Municipal Planning Commission

AGENDA

Monday, April 3, 2023 — 7:00

SUBJECT: Master Plan Application Review

SHEET 1 OF 1
PRELIMINARY PLAT/FINAL PLAT

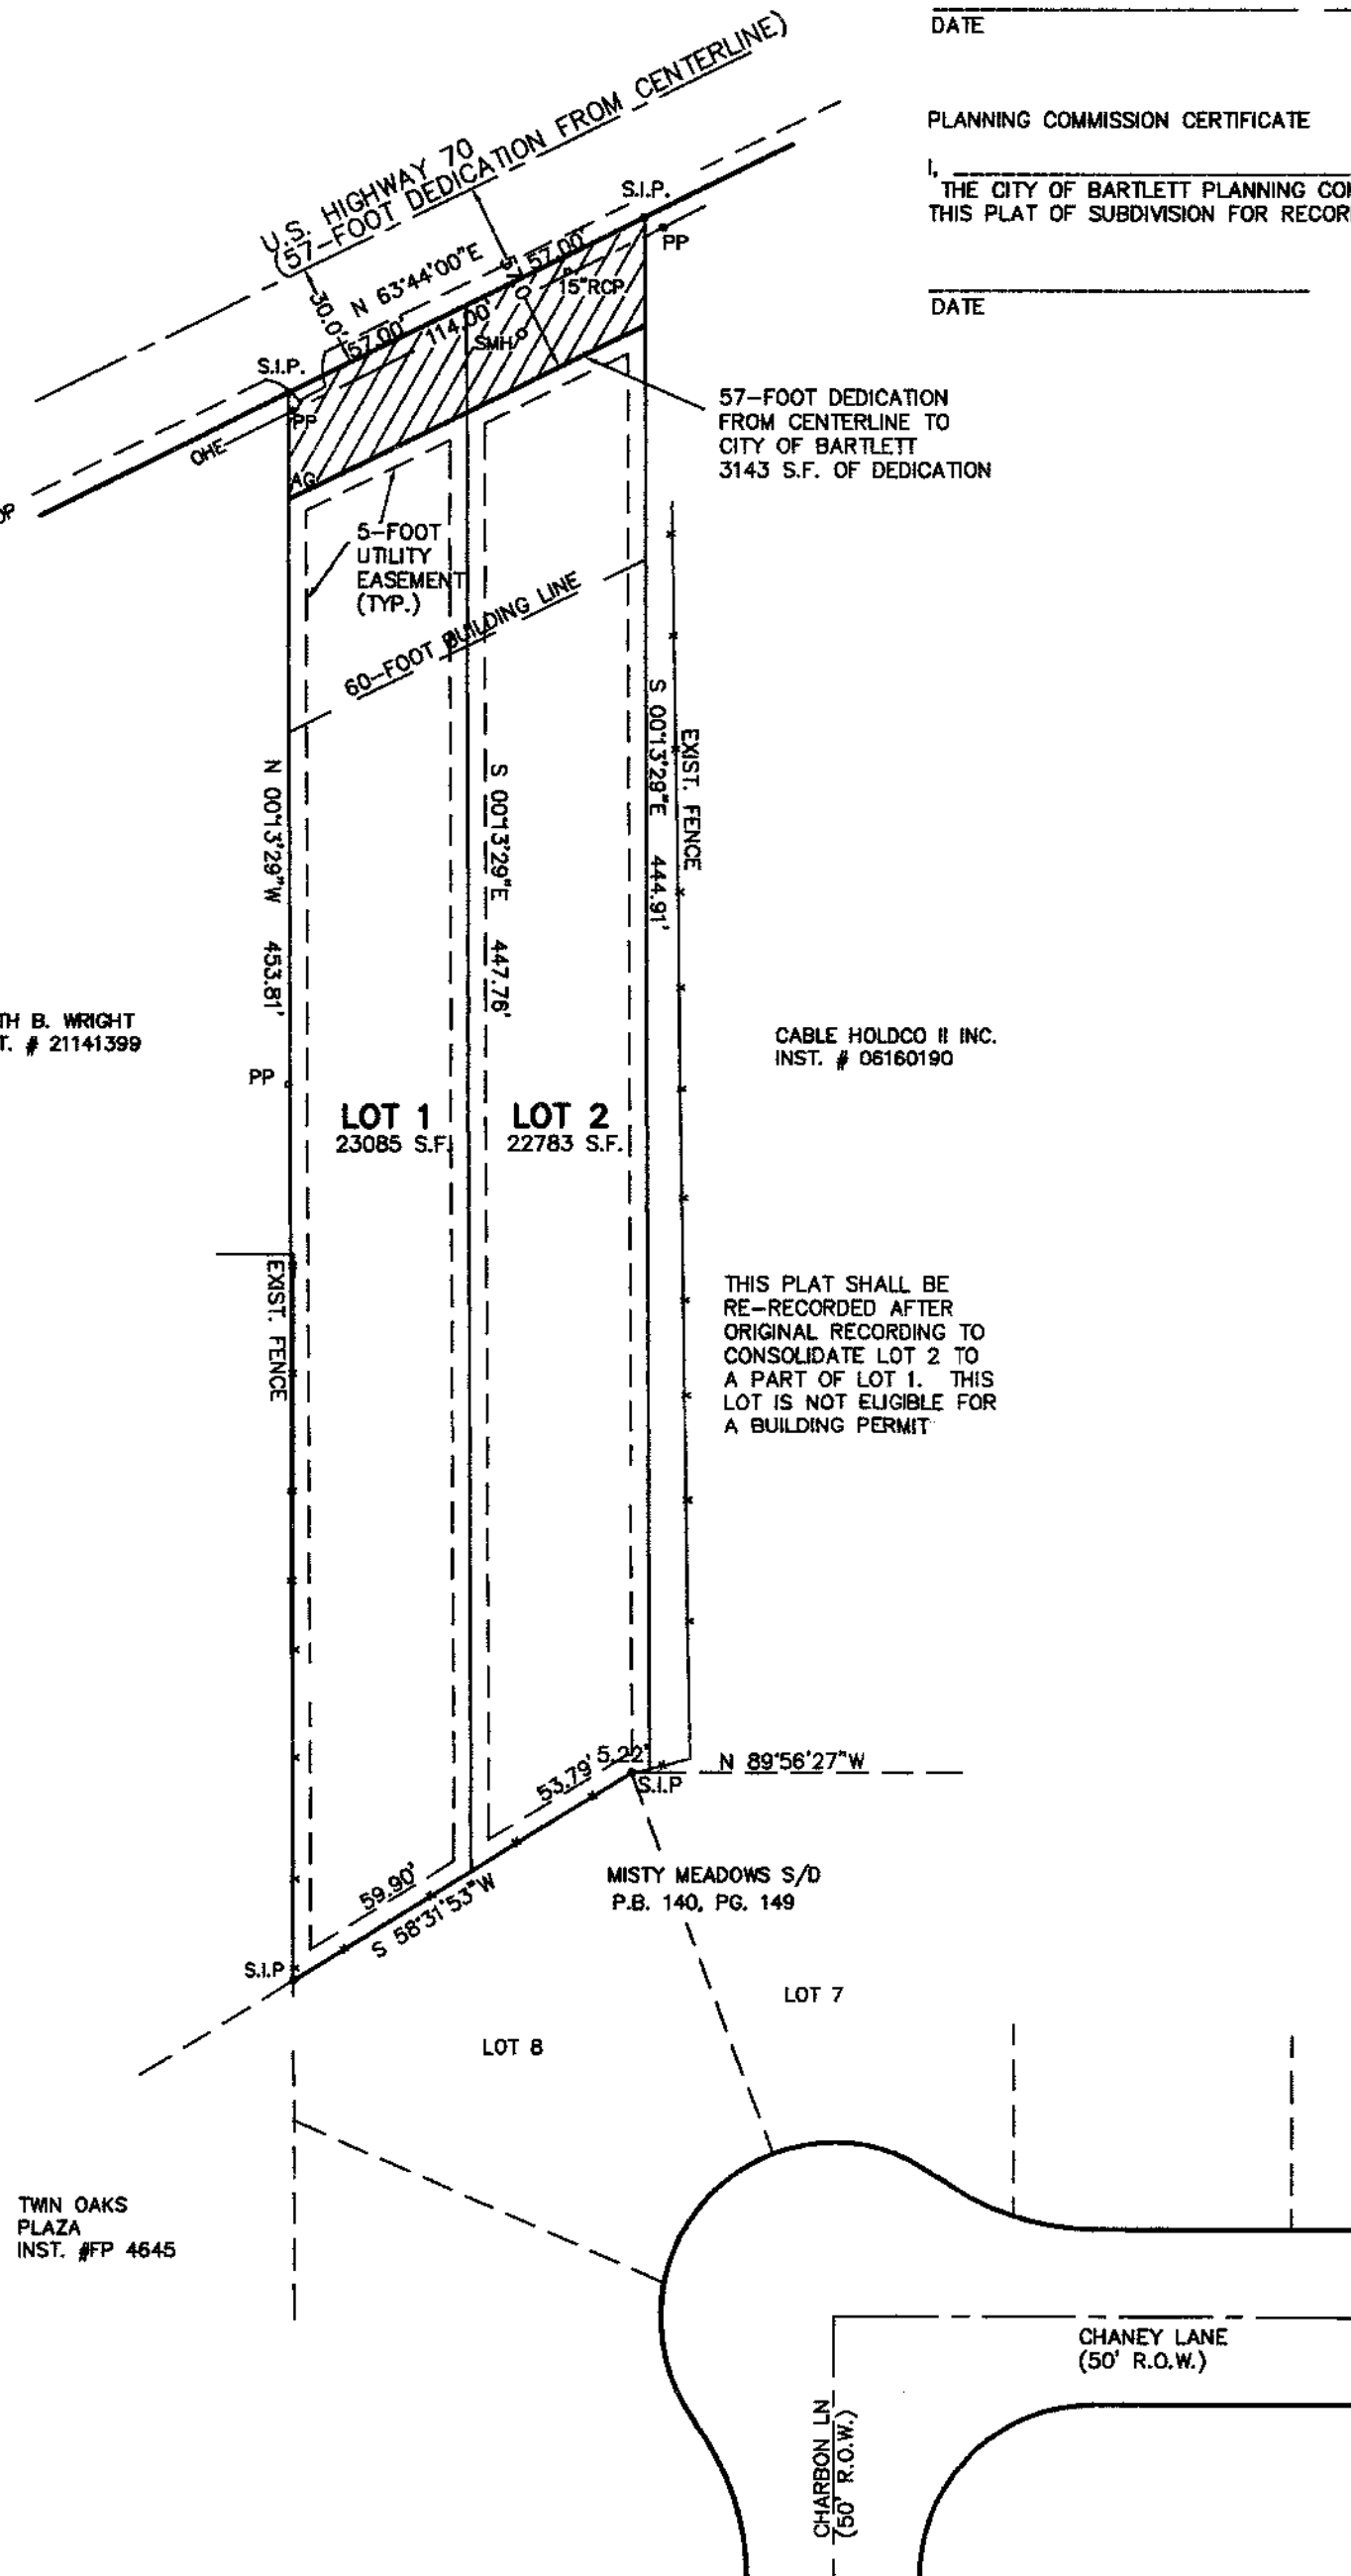
2. All new utilities shall be underground.
3. All mark-ups and corrections shall be addressed on the revised plans.

4. A Final Plan application will be required as this parcel is not a legal lot of record.
5. ROW dedication of 57' from the centerline will be required, this shall be called out as "To be dedicated to the City of Bartlett."
6. Any public easements for utilities shall also be shown

7. Construction plans will be required.
8. ROW dedication of 57' from the centerline will be required dedication for HWY 70.
9. Construction of a paved shoulder of an additional 10' wide will be required on HWY 70. This additional asphalt section shall be full depth pavement, consistent with the existing roadway, and must conform to TDOT standards. This shall be added to the construction plans with TDOT approval. This shall be coordinated with TDOT as this is a state route.
10. The driveway on HWY 70 will require a TDOT permit. A construction detail shall be added to the plans.
11. Utility work in HWY 70 will require a TDOT permit.

12. No Sewer Plan has been submitted but will be required to show the sewer service connection.
13. There is an existing sewer line along HWY 70, the Developer's engineer is responsible for insuring that the sewer is deep enough to provide sewer service for the desired building's location.
14. Since this project is located in the Fletcher Creek Sewer Basin new tap approval is dependent on developer receiving written approval from the City of Memphis for sewer connection. Developer's engineer will be responsible for establishing if an existing tap is in place. If no tap exists then the developers engineer shall work with City of Memphis on holding tank design and approval.

15. Developer's engineer will be responsible for establishing if an existing tap is in place. If not, a new 2" Water Service will be required. Applicant must request and purchase a Water Meter. The water tap will need to be a reverse tap.

16. An 8" water line is available across the street and/or directly behind the property. It may be necessary to loop these for the required Fire flows. This would require HWY 70 to be bored. In addition, a 12" waterline will need to be installed across the entire frontage on Hwy 70. Certified as-builts will be required on the public water.
17. An additional fire hydrant may be required on site.
18. Fire protection must be approved by the City of Bartlett Fire Marshall.

19. Detention will be required.
20. Applicant's engineer shall submit the stamped and signed detention calculations for the proposed detention basin and show the 'pre' and the 'post' runoff for the 2, 5, 10, 25-year storms.
21. A structure table and pipe table must be labeled to show public and private drainage lines.
22. There is an existing blue line stream along the south property line. The stream water ordinance requires a minimum buffer of 30' from the stream in all locations with an overall average of 60'. This stream buffer shall be drawn in and hatched as non-buildable area on both sides of the existing blue line stream.

23. The Engineer shall prepare and submit a SWPPP to TDEC with a copy sent to the City of Bartlett Engineering Department.
24. Once TDEC has issued the Notice of Coverage (NOC), a copy shall be sent to the City of Bartlett Engineering Department.
25. Metal posts with wired backed fence are required on the proposed silt fences.

1. The subject property received a variance from the Board of Zoning Appeals in February 2023 for the lot width of the proposed Lots 1 and 2 along the Highway 70 frontage. The "C-H" zoning district requires 80 linear feet of lot frontage. Lots 1 and 2 will have 57 linear feet of lot width along Highway 70 for the limited time they are recorded as two separate lots before being consolidated and re-recorded as one lot of record thus removing the need for a lot width variance.

1. The applicant must add Landscape Plate 23D to the plat along the southern property line that borders Misty Meadows Subdivision.
2. The commercial property owner will be responsible for landscape maintenance of the entire lot and the fence adjacent to the residential neighbors in perpetuity.
3. The applicant must obtain Final Plan and Site Plan approval from the Planning Commission.
4. The applicant must obtain Site Plan approval from the Design Review Commission.
5. The applicant shall be present at the meeting in order to make decisions relative to any changes that may be suggested by the Planning Commission.

SHEET 1 OF 1
FINAL PLAT
Re-Subdivision of Part of Lot 8
Ferguson Subdivision (unrecorded)
BARTLETT, TENNESSEE

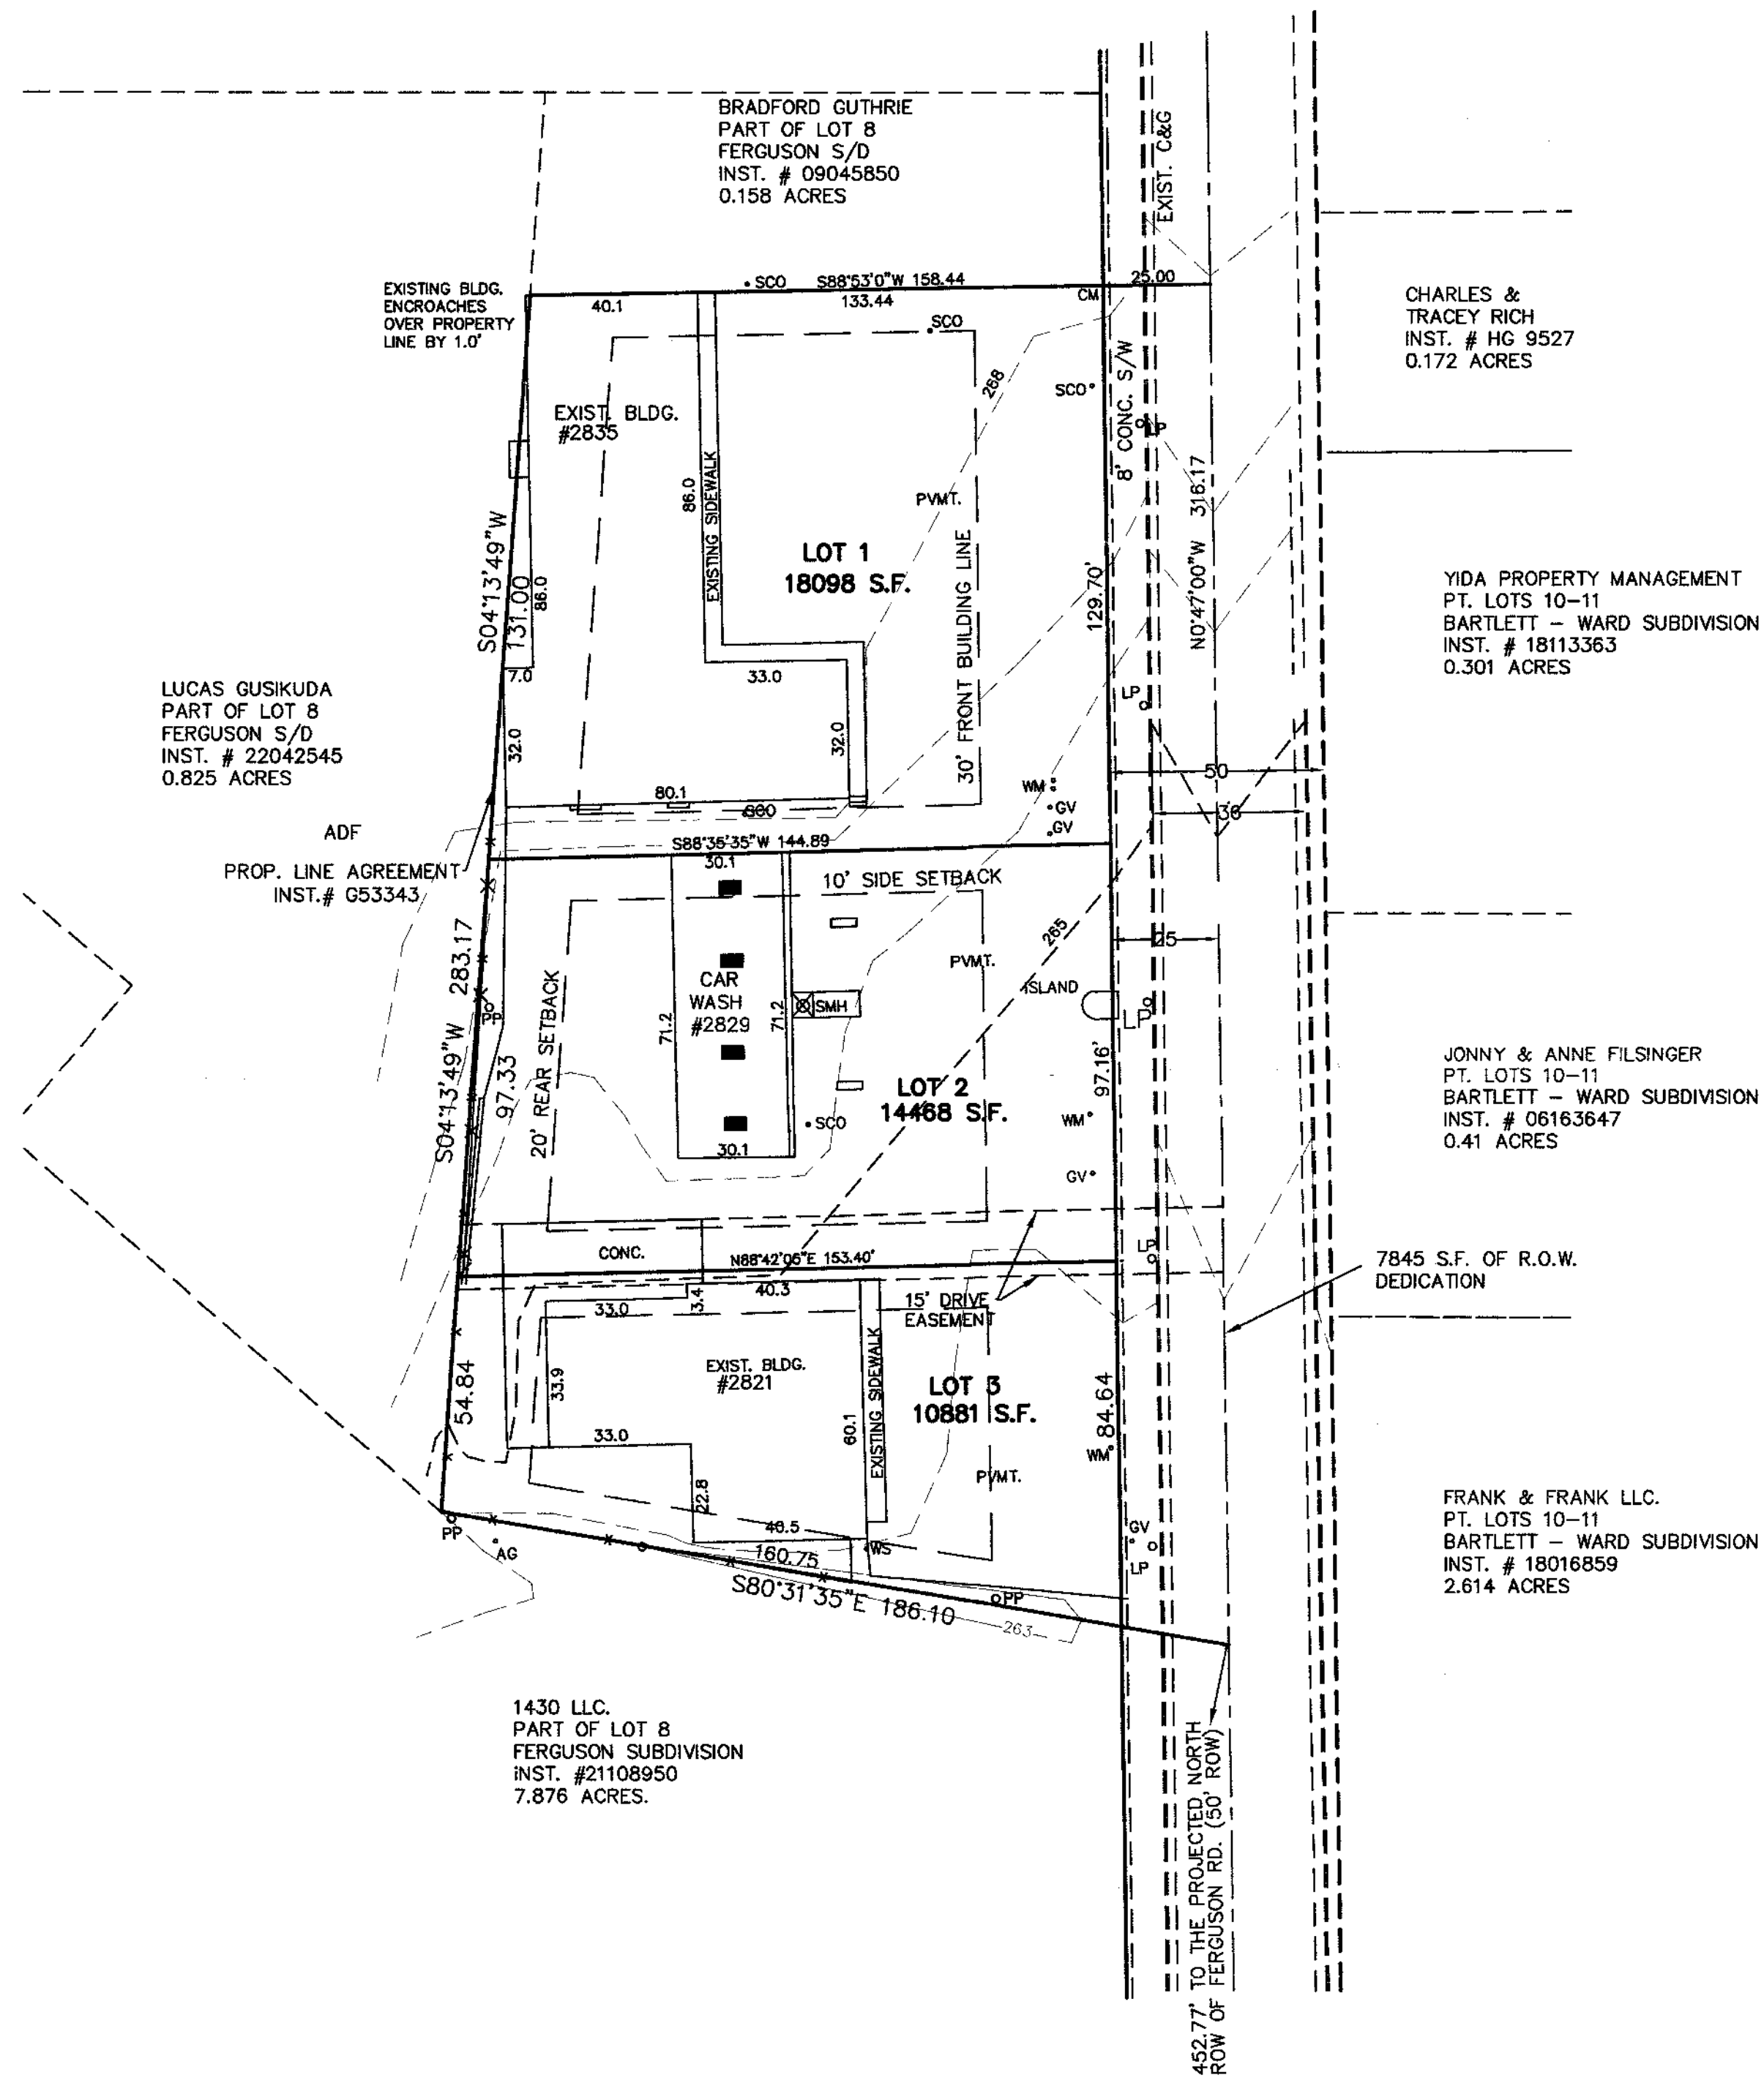
2. The existing sewer services currently cross lot lines, both within the area being recorded and to neighboring businesses. Each lot must be separately and appropriately serviced and connected as part of this contract.
3. All new utilities shall be underground.
4. All mark-ups and corrections shall be addressed on the revised plans.

5. A Final Plan application will be required.
6. Any public easements for utilities shall also be shown.
7. ROW dedication of 25' from the centerline will be required; this shall be called out as "To be dedicated to the City of Bartlett."

9. No Sewer Plan has been submitted but will be required to show the sewer service connections. These are marked on-site.
10. The existing sewer services currently cross lot lines, both within the area being recorded and to neighboring businesses. Each lot must be separately and appropriately serviced and connected as part of this contract.

1. The applicant shall revise plat to utilize the Main Street Commercial Overlay building setbacks (Article VI.26) and 5-foot utility easements and comply with Zoning Ordinance.
2. Should the applicant add on to an existing structure or construct new buildings, the applicant shall use the Main Street Commercial Overlay for the Planning Commission and Design Review Commission site plans.
3. The applicant shall make application for Construction and Final Plans to legally record this subdivision.
4. The applicant shall be present at the meeting in order to make decisions relative to any changes that may be suggested by the Planning Commission.
